HISTORIC AND DESIGN REVIEW COMMISSION

HDRC CASE NO: 2022-016
ADDRESS: 1220 E COMMERCE ST
LEGAL DESCRIPTION: NCB 602 BLK LOT N IRR 550.35 FT OF 22
ZONING: D
CITY COUNCIL DIST.: 2
APPLICANT: Killen, Griffin & Farrimond, PLLC
OWNER: QUADRANT COMMERCE OWNER LP
TYPE OF WORK: Construction of a 4-story residential structure
APPLICATION RECEIVED: December 28, 2021
60-DAY REVIEW: Not applicable due to City Council Emergency Orders
CASE MANAGER: Edward Hall

The applicant is requesting conceptual approval to construct a 5-story, multi-family residential structure at 1220 E Commerce, located within the Downtown Design District. The proposed new construction will feature wrapped, structured parking and approximately 340 residential units.

Historic and Design Review Commission
Design Review Committee Report

SITE PLAN | CHERRY X COMMERCE | SAN ANTONIO, TEXAS

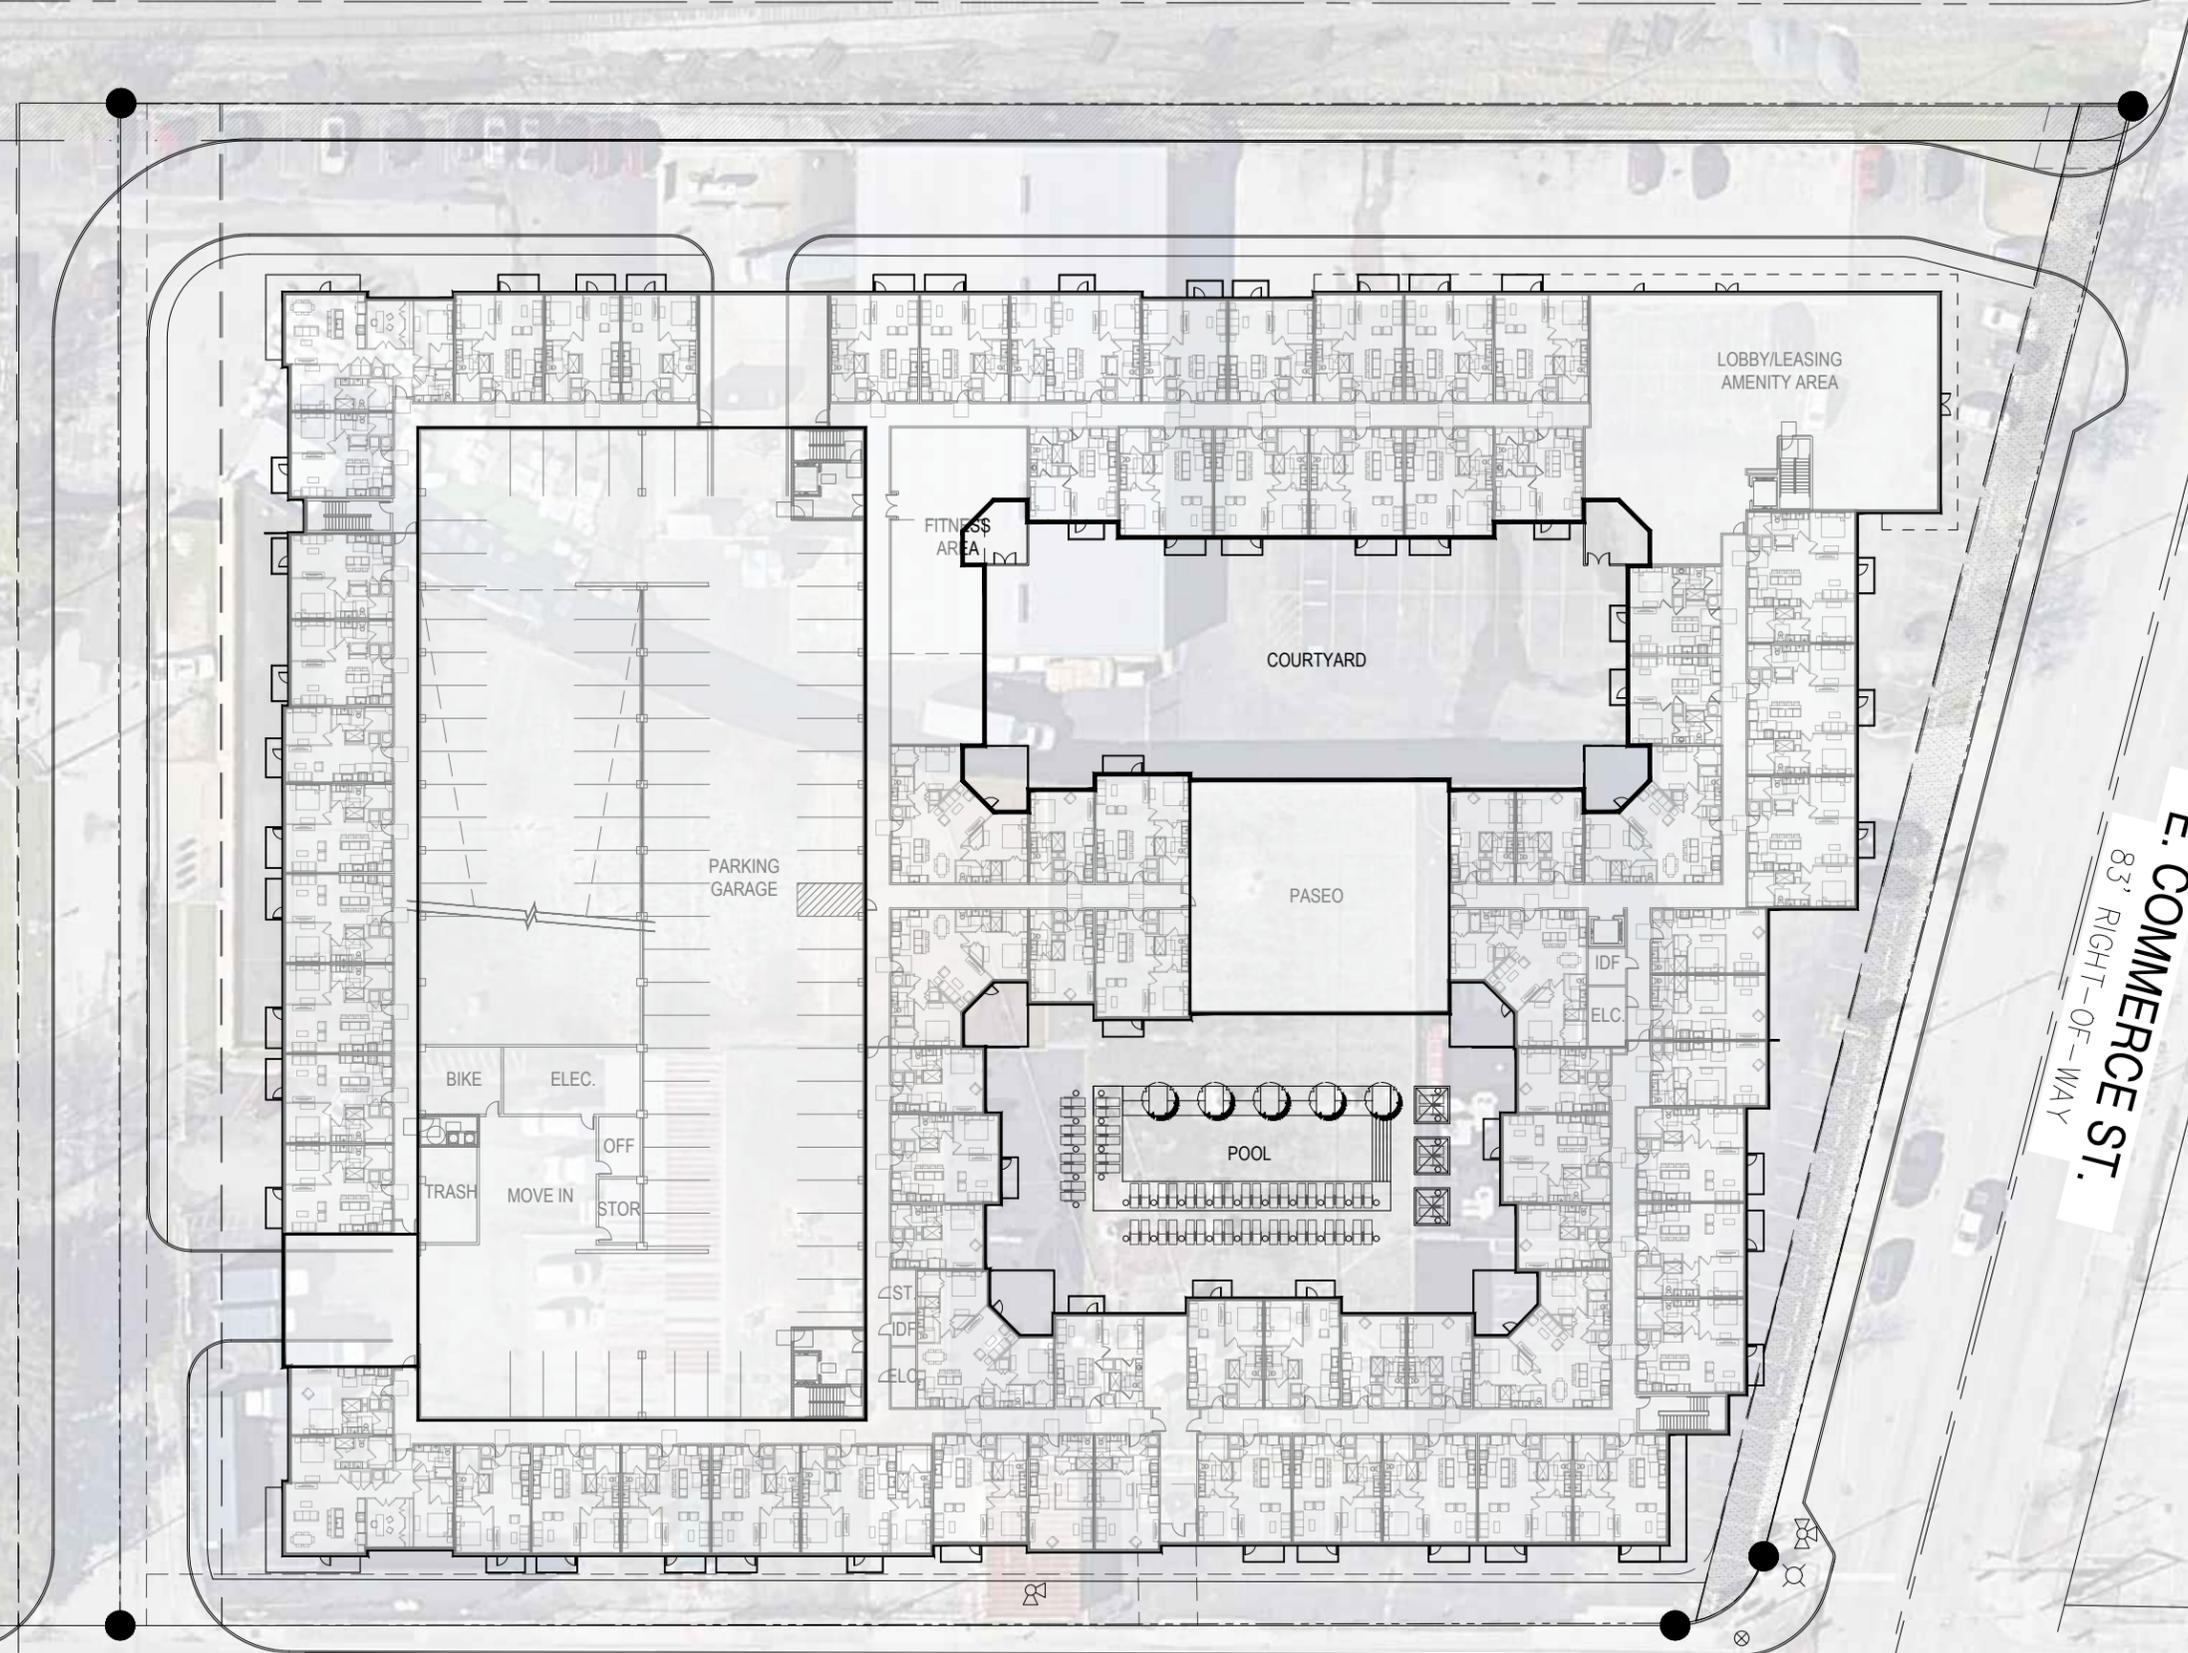
- e. SIDEWALK & SETBACK WIDTH – The applicant has noted a sidewalk width on E Commerce of approximately 13’ – 6” from the property line, with additional sidewalk with within the public right of way. On other streets, such as N Cherry and along the proposed fire lanes, the applicant has proposed sidewalks of at least six (6) feet in width. Staff finds the proposed sidewalks and setback widths to be appropriate and consistent with the Downtown Design Guide.

- f. LANDSCAPE & HARDSCAPE – Per the submitted application documents, the applicant has noted landscaping elements being planted within sidewalks and street setbacks. The applicant has noted the installation of low growing elements as well as street trees. Generally, staff finds the proposed landscaping noted in the submitted renderings to be appropriate and consistent with the Downtown Design Guide; however, staff finds that a fully developed site plan should be submitted for review and approval.

MS: Questions about sidewalk width (BB: Sidewalks will be 5'; sidewalk on private will meet public sidewalk for as many as 8' in some locations).

- i. That the applicant confirm a ground floor retail space height of at least fourteen (14) feet, as noted in finding g.
- ii. That a detailed landscaping plan be submitted for review and approval, as noted in finding f.
- iii. That all finish materials be of high quality and be submitted to staff for review prior to final approval, and that standing seam wall panels feature a smooth finish with no ridges or striations, as noted in finding l.
- iv. That the proposed vinyl windows feature dark colors, no faux divided lites or faux internal grilles, and be installed to feature a depth of at least two (2) inches.
- v. That the applicant develop and submit a detailed signage plan for review and approval.
- vi. ARCHAEOLOGY – The project shall comply with all federal, state, and local laws, rules, and regulations regarding archaeology, as applicable.
